April 19, 1977

Subject: Dresden Station Units 2 and 3
Quad-Cities Station Units 1 and 2
Mark I Containment - Drywell to Torus
Differential Pressure Instrumentation
NRC Docket Nos. 50-237/249/254/265

Δ P PUMP-BACK SYSTEM MODIFICATION

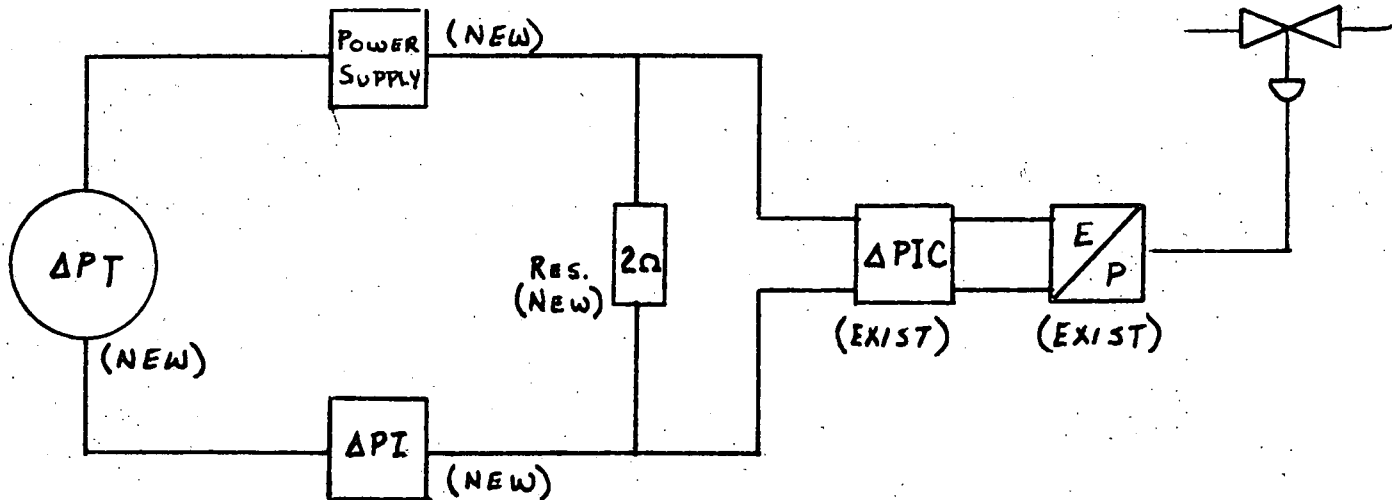
The modification includes the substitution of a differential pressure transmitter (ΔPT) for the existing drywell and torus pressure transmitters (90X-3) and a digital differential pressure indicator (ΔPI). A schematic of the modified system is provided in Figure 1 (attached). Also provided in the Figure are instrument accuracies for the new equipment. The modified system will provide continuous redundant indication of the drywell-torus ΔP , and will be accurate to within 0.1 psid as recommended by the NRC in Reference (a).

* ΔPT : 0 to 150" H₂O 0 to 5.42 PSI adjustable to
0 to 3 PSI input 4 to 20 MA output
Accuracy .2% of calibrated range

* ΔPI : Readout 0.00 to 3.00 PSI
Accuracy .1% range

*Power: 24 VDC output - 115 VAC input
Supply

*Resistor: 2Ω /1% tolerance
